CITY OF MUSKEGON  
**HISTORIC DISTRICT COMMISSION**  
**MINUTES**

**July 7, 2020**

#### **Case 2020-13 – 100 Diana – Supplemental Application Info**

Bedroom window to be raised up

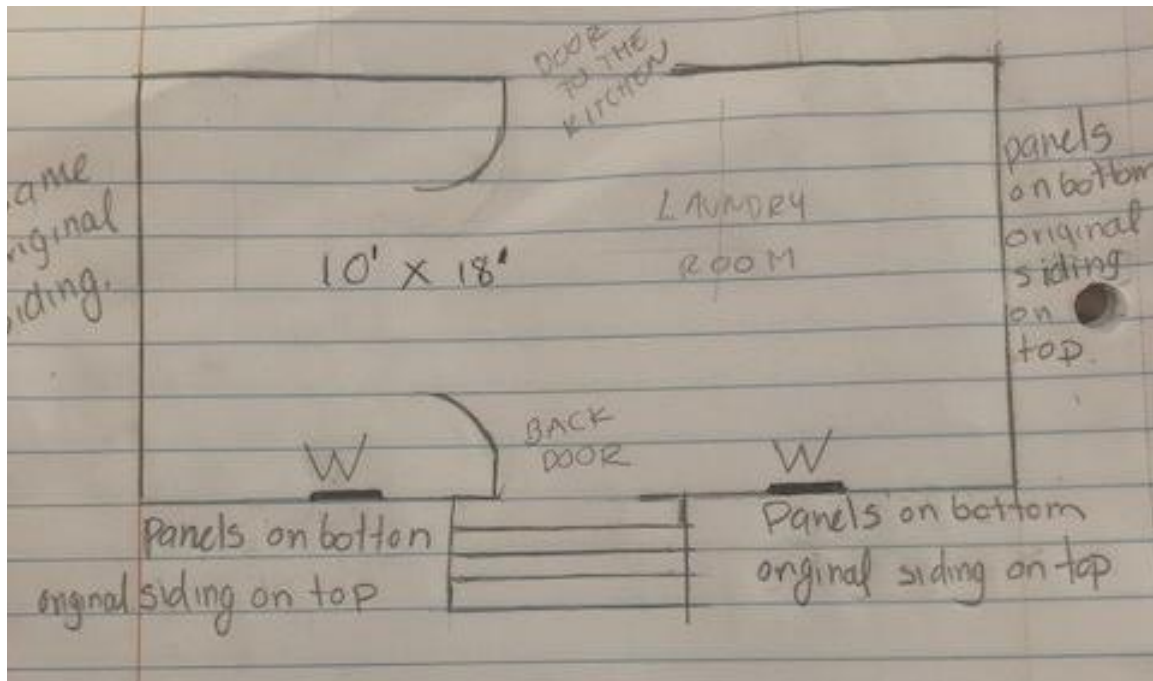
The board moved on to discuss the window replacement. A. Riegler asked if the windows were operable. Ant. Figueroa stated that most of the glass on the windows were broken and that the replacement windows he was proposing would not affect any existing window trim. K. George noted that the replacement windows would be evenly divided like the existing windows, but that the grills on the new windows would not match the two-over-two configuration of the existing windows. S. Radtke stated that he would rather see one-over-one replacement windows because of the architecture of the house, K. George and A. Riegler agreed. S. Radtke noted that the applicant was requesting to shorten the upper windows by 11" and J. Pesch stated that the bases of five 66"x29" windows on the second story were proposed to be raised 11" higher. Ant. Figueroa stated that they were currently 8" above the floor. K. George noted that code would require tempered glass in new windows less than 18" from the floor for safety reasons and asked what the exterior would look like if the base of the window was raised up. Ant. Figueroa stated that he would match the existing paneling surrounding the window on the side of the house at the bases of the new windows. K. George stated that adding the raised panels below the windows would significantly change the appearance of the house. A. Riegler noted that changing the size of the window openings is strongly discouraged by the HDC local standards, and that such requests are rarely, if ever, approved in a situation like this. She suggested that window guards or special locks could be installed on the interior to provide a level of safety without affecting the exterior appearance. S. Radtke agreed that the proposed change would drastically alter the appearance of the house and was concerned about losing the tall windows that are common to the Italianate style. K. George noted that the tempered glass would raise the cost of the windows, but would be easier with a single pane in the bottom of the window. S. Radtke stated that, while he did not prefer replacing original windows, if the board approved replacement windows due to the age of the windows, apparent poor maintenance in past years, and the cost of custom made windows with a two-over-two configuration, he would be willing to allow a one-over-one configuration for the replacement windows in the interest of maintaining some semblance of the original intent of the architecture.

As noted in the list above, five of the windows in the second floor bedrooms are proposed to be replaced with windows that are shortened by 11" at the base, as shown in the below photos:

A motion that the HDC approve the request to 1) demolish and rebuild the 8'x18' room on the back of the house in the layout provided in the July 7th, 2020 HDC Staff Report's Case 2020-13 – 100 Diana – Supplemental Application Info, 2) remove the existing wood windows and replace them with new windows in a one-over-one configuration in the same size and dimensions as the original openings with the recommendation that, where possible, the existing wood windows be restored instead of replaced, and 3) remove and rebuild the front steps to match the current 5' width as long as the work meets all zoning requirements and the necessary permits are obtained was made by A. Riegler, supported by S. Radtke and approved with S. Radtke, T. Emory, K. George, L. Wood, and A. Riegler voting aye.

The 8'x18' room proposed to be demolished will be rebuilt to be 10'x18' with fewer total windows than exist currently as shown in the below drawing:

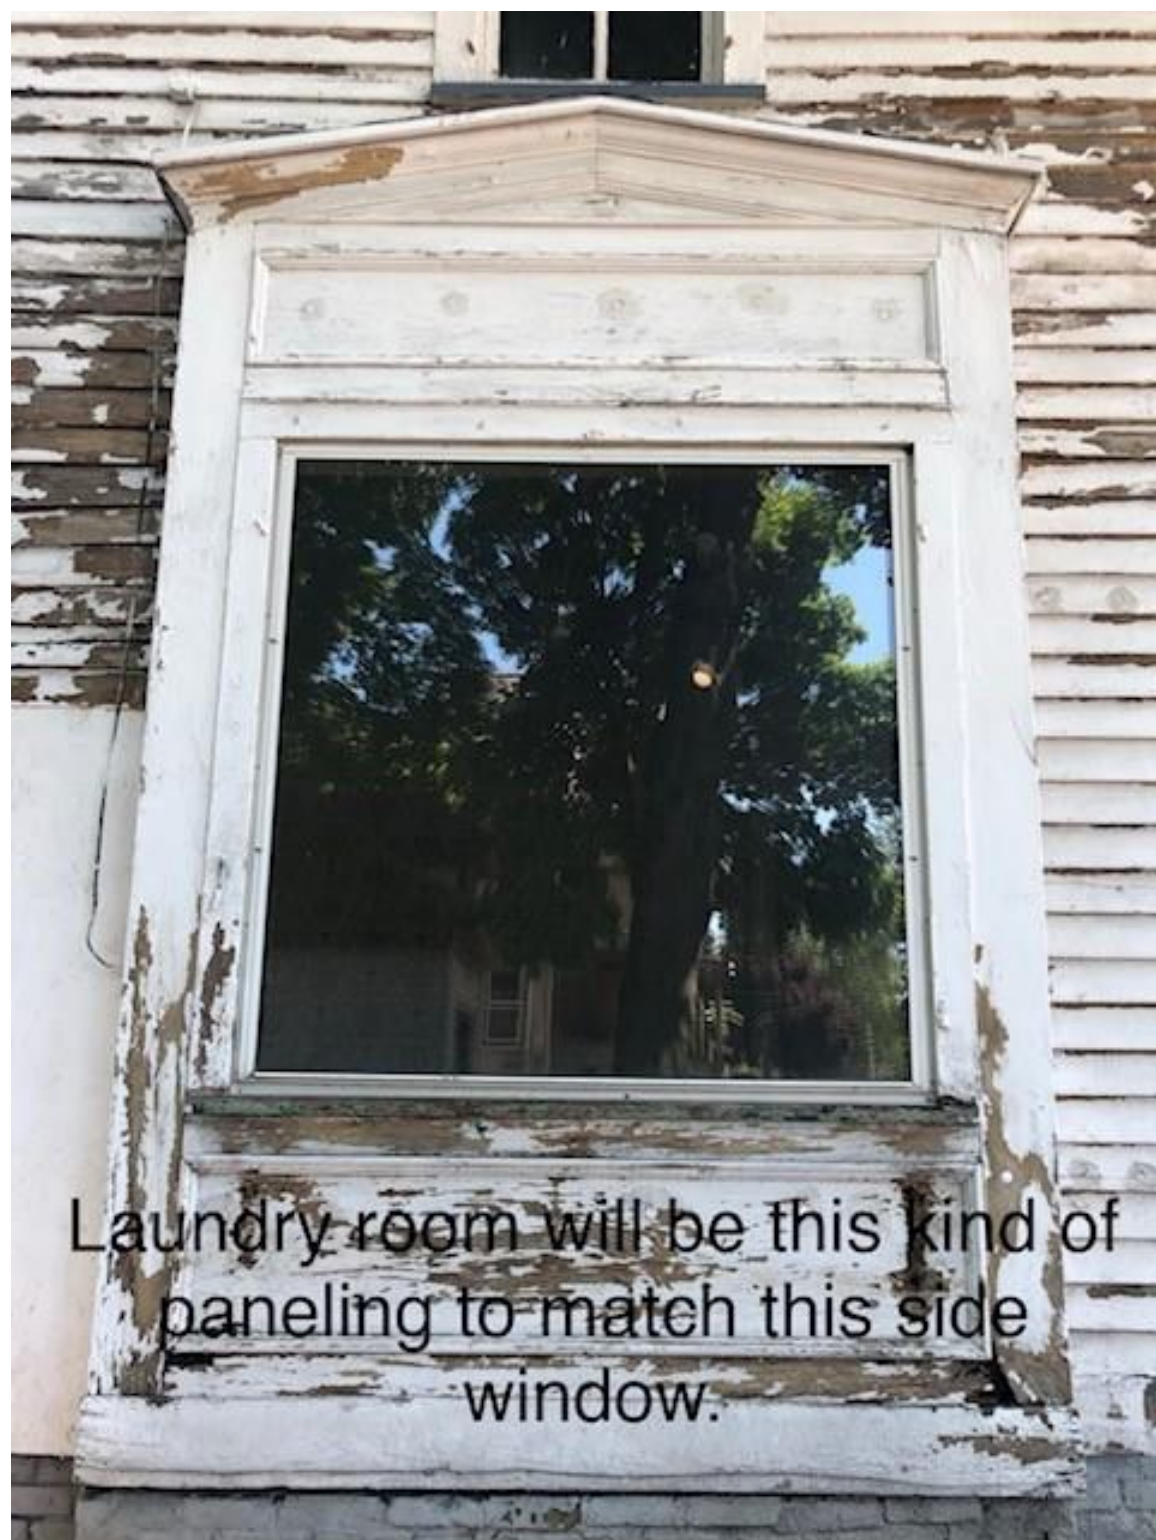
S. Radtke requested that the discussion be separated into the three parts of the request, beginning with the request to demolish the 8'x18' room on the back of the house. Ant. Figueroa explained that the portion of the house he was requesting to demolish was in such bad condition that demolition and new construction was the best option to make that area safe.

J. Pesch explained the annotated drawing of the new construction included in the HDC Staff Report's Case 2020-13 – 100 Diana – Supplemental Application Info (attached below), and that it would be sided on the exterior to match the rest of the house on the upper portion while the lower portion would be finished with paneling similar to what surrounds the picture window on the west side of the house. Ana. Figueroa stated that there would only be two windows in that space on the back of the house, one on each side of the new door, once the room was rebuilt, and that the new construction would have the same shed roof as the existing room.

K. George noted that the existing room that was planned to be demolished was probably not originally enclosed because it lacked a foundation. T. Emory stated that it was likely an open porch that was closed in at some point. Ant. Figueroa stated that he planned to pour ten total

footings to support the new, 10'x18' room planned to be constructed. K. George noted that the new construction would likely need a full foundation rather than footings because it would be a room, A. Riegler agreed. K. George noted that the rest of the house had a brick foundation, and Ant. Figueroa stated that there was a mix of brick and block making up the foundation of the house, as a result of past repairs. K. George stated that the material used for a new foundation in the back of the house was less of a concern since it would not be very visible from the street, A. Riegler agreed.
